September 6, 1976
Docket No.: 50-247

INDIAN POINT NUCLEAR GENERATING UNIT NO. 2

AMENDMENT TO FACILITY OPERATING LICENSE

Amendment No. 20
License No. DPR-26

FIGURE 2.1-1

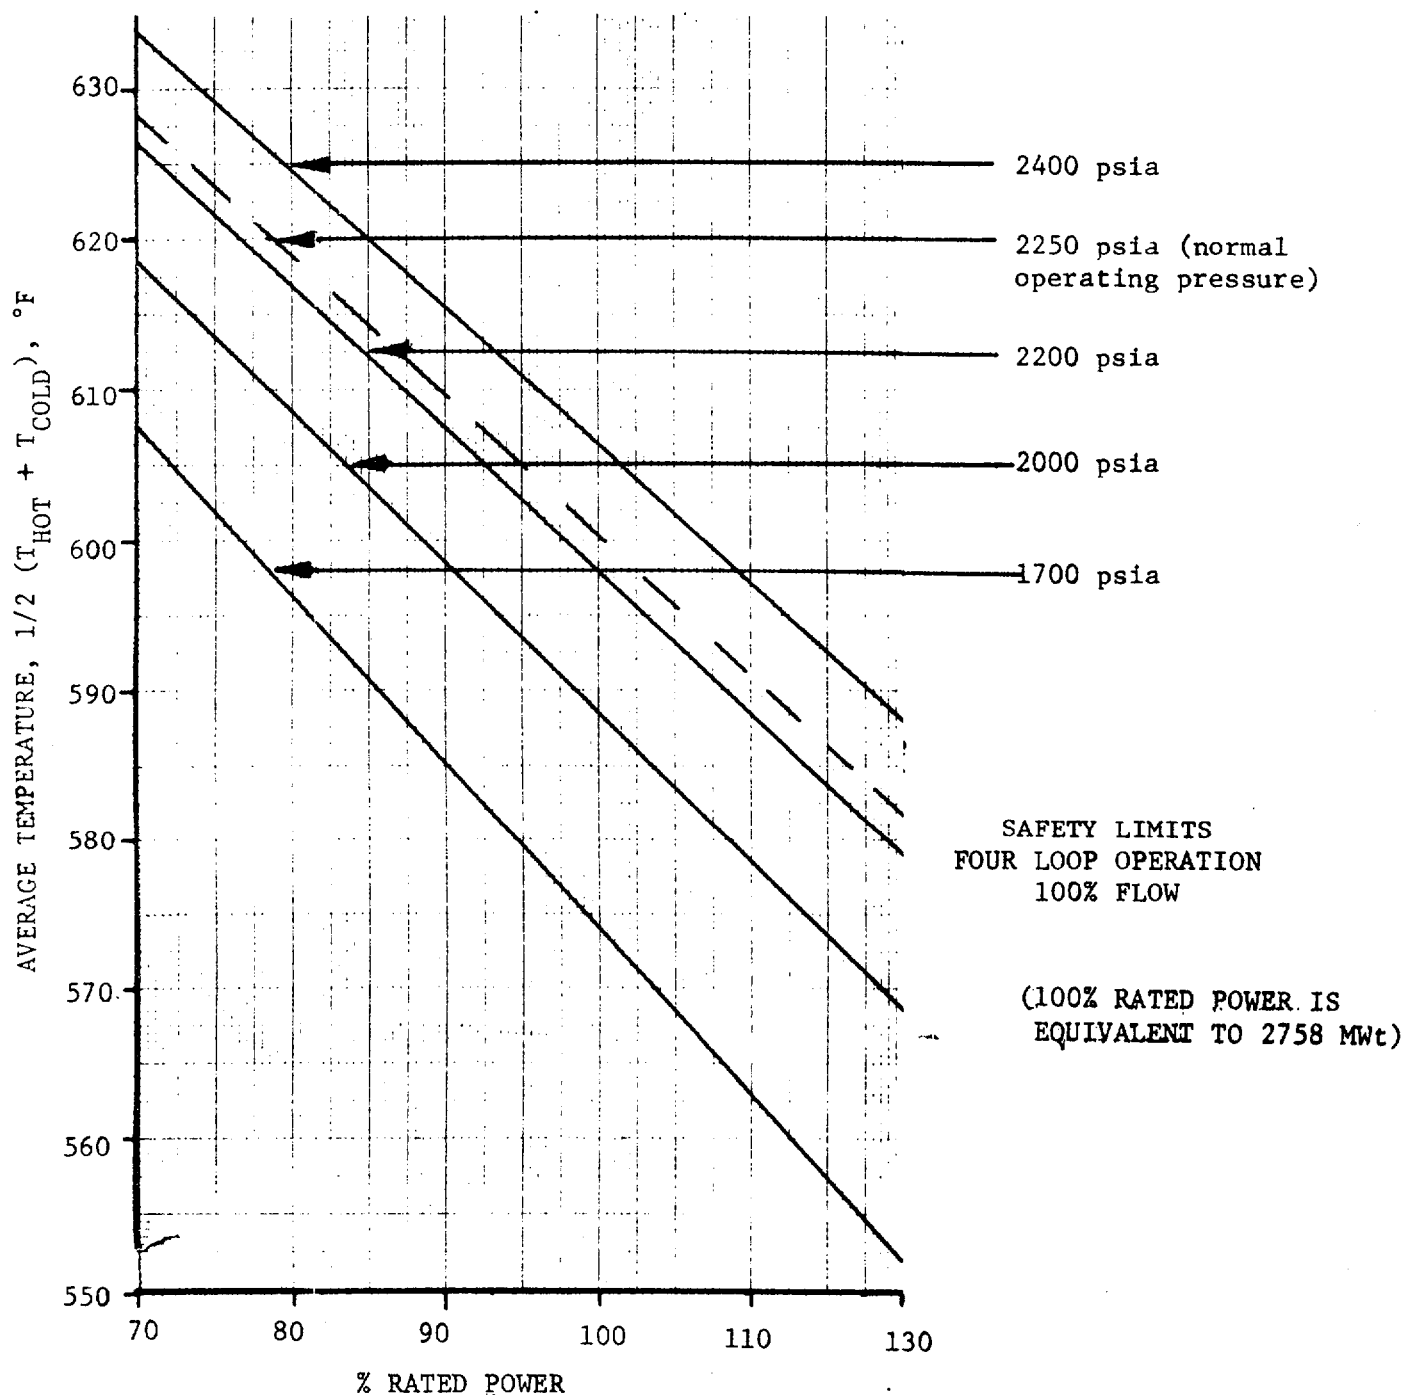
The curves of Figure 2.1-1 and 2.1-2 represent the loci of points of thermal power, coolant system pressure and average temperature for which the DNBR is no less than 1.30. The area where clad integrity is assured is below these lines,

Figure 3.10-1

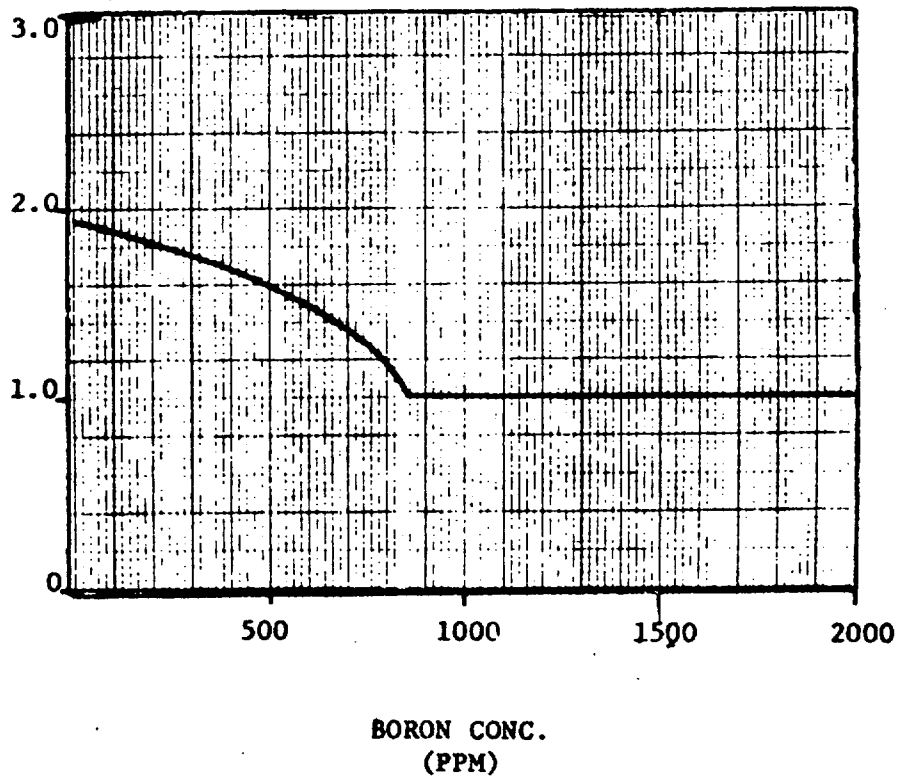
The shutdown margin shall be at least as great as shown in Figure 3.10-1.

Trip shutdown reactivity is provided consistent with plant safety analysis assumptions. One percent shutdown is adequate except for steam break analysis, which requires more shutdown if the boron concentration is low. Figure 3.10-1 is drawn accordingly.

Figure 3.10-3

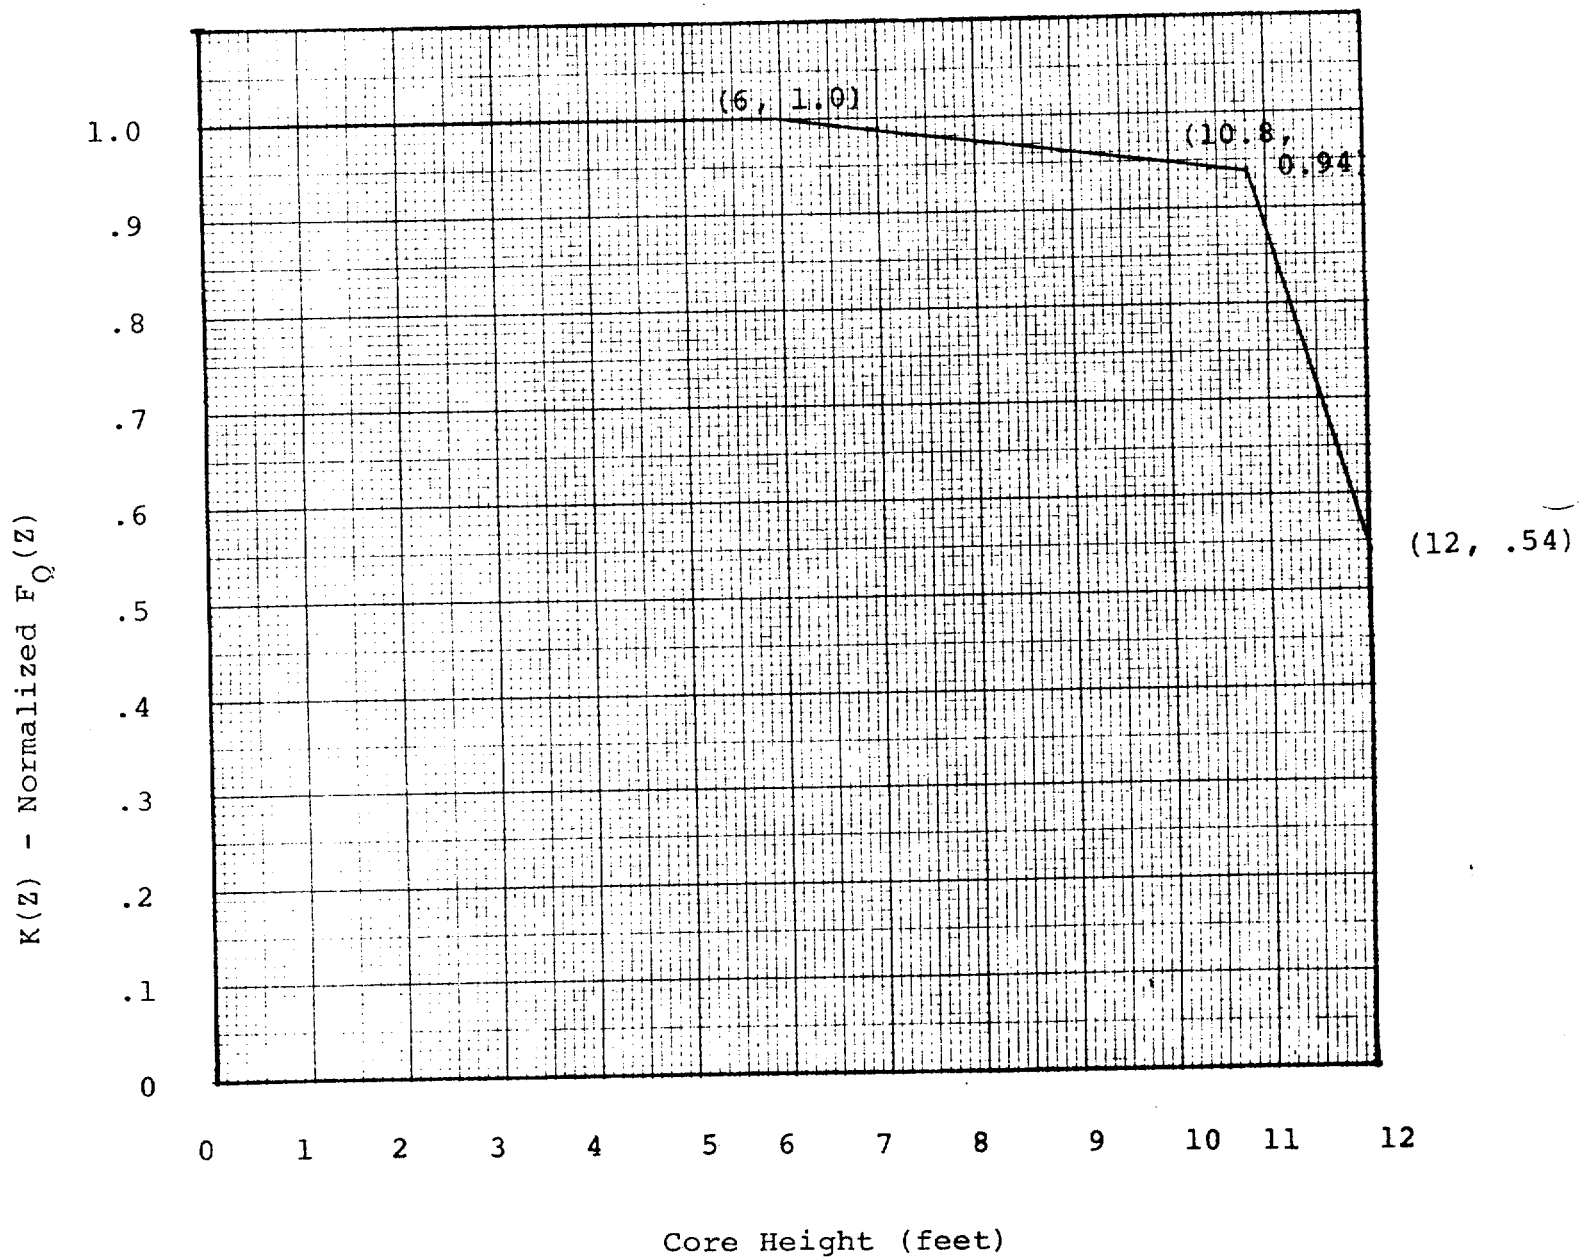
3.10.4.2 When the reactor is critical, the control banks shall be limited in physical insertion to the insertion limits shown in Figure 3.10-3 or Figure 3.10-4.

Figure 3.10-4

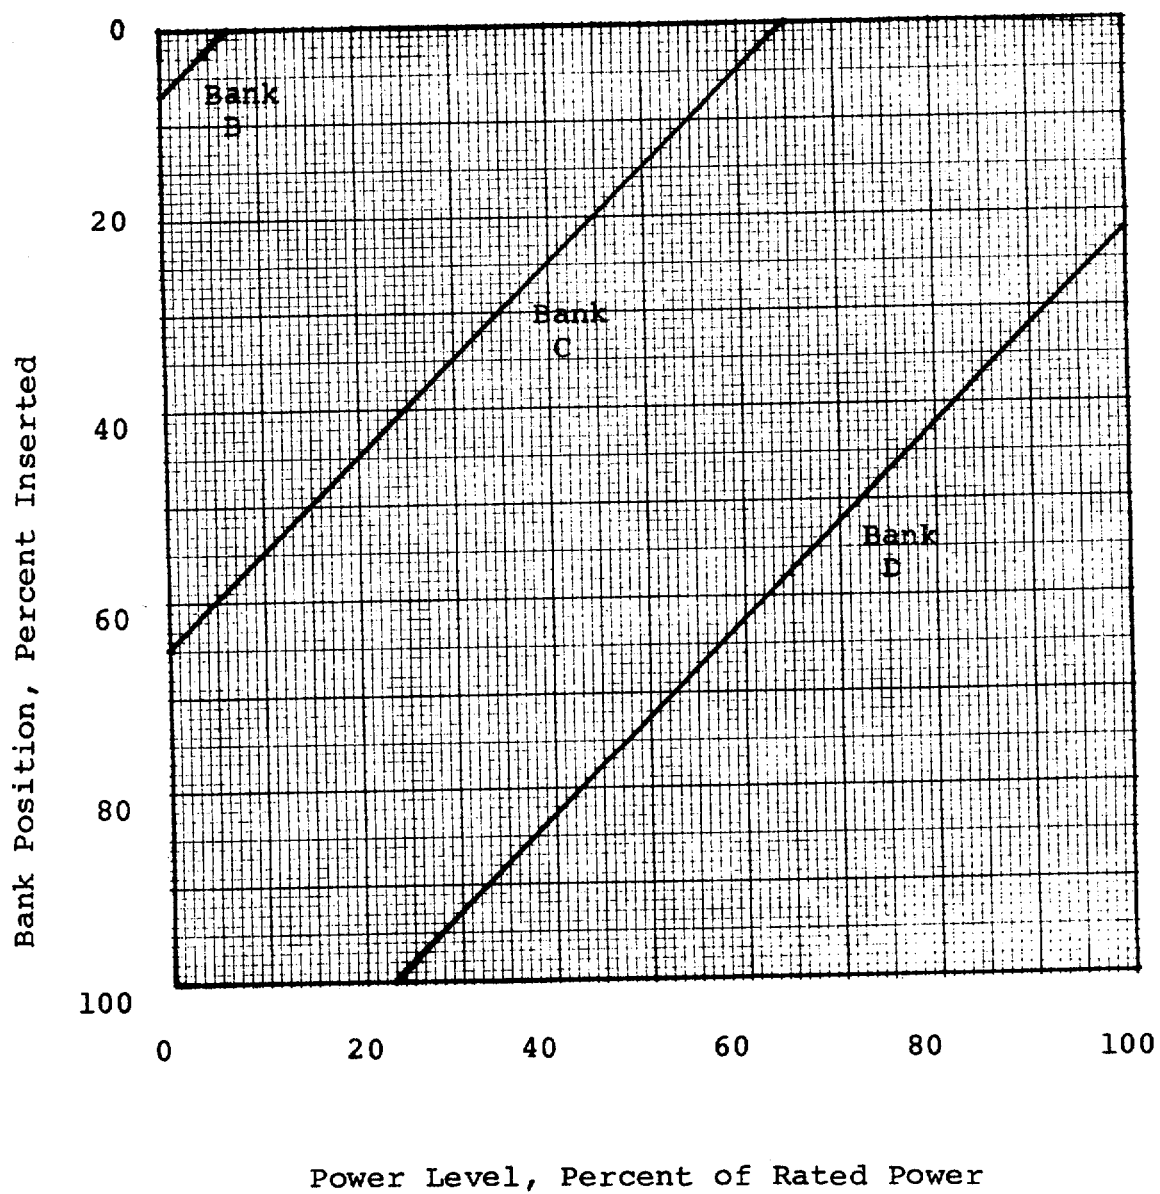
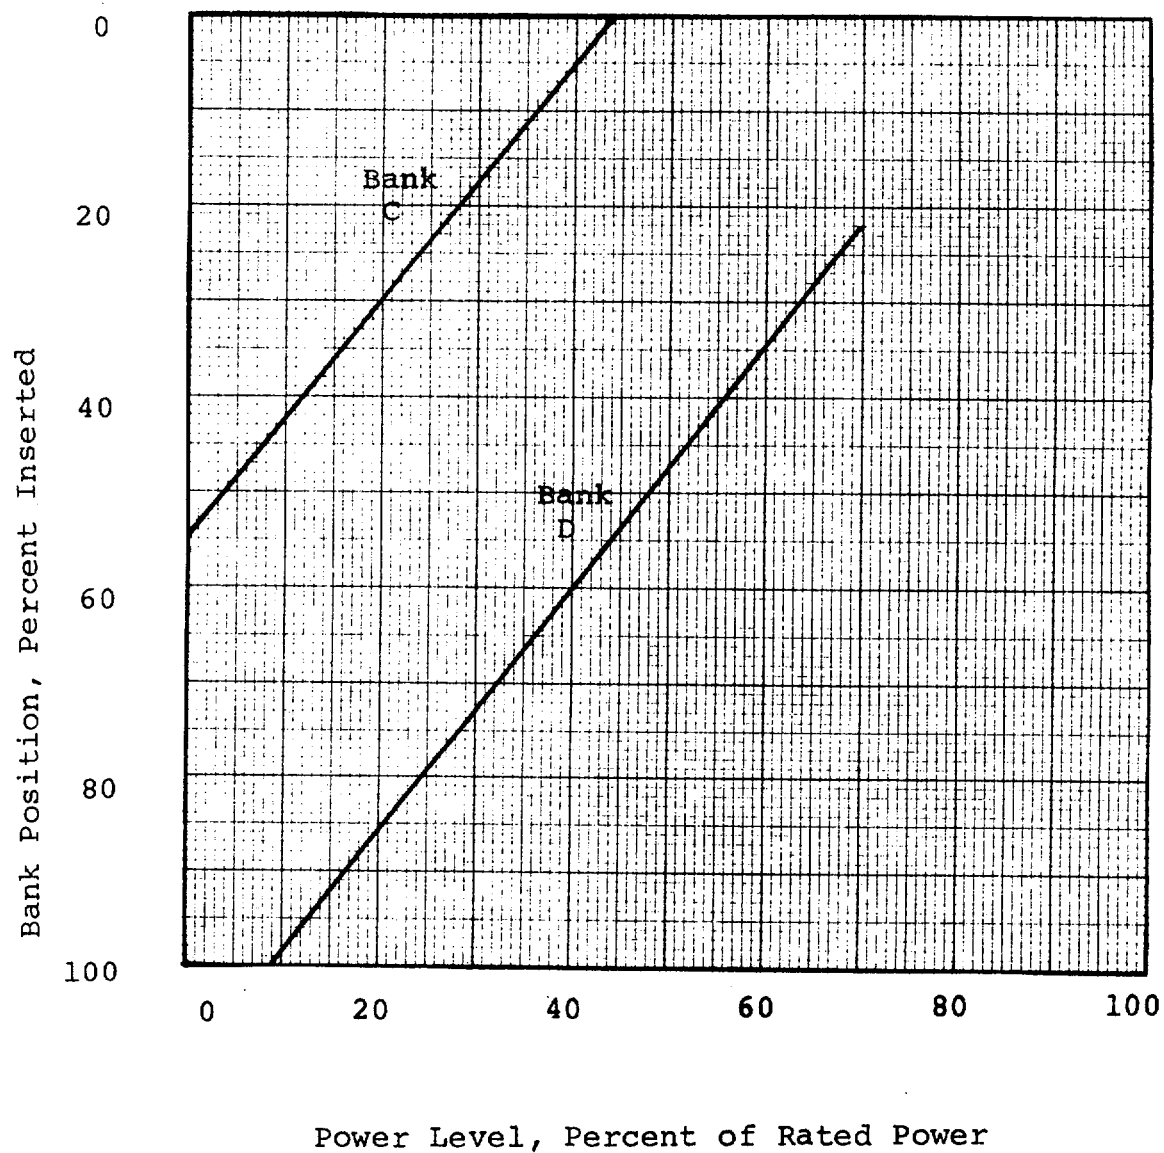
These limiting hot channel factors are higher than those calculated at full power for the range from all control rods fully withdrawn to maximum allowable control rod insertion.(3) The control rod insertion limits are covered by Specification 3.10. Higher hot channel factors could occur at lower power levels because additional control rods are in the core. However, the control rod insertion limits dictated by Figure 3.10-3 insure that the DNBR is always greater at partial power than at full power. For three loop operation the insertion limits of Figure 3.10-4 apply.
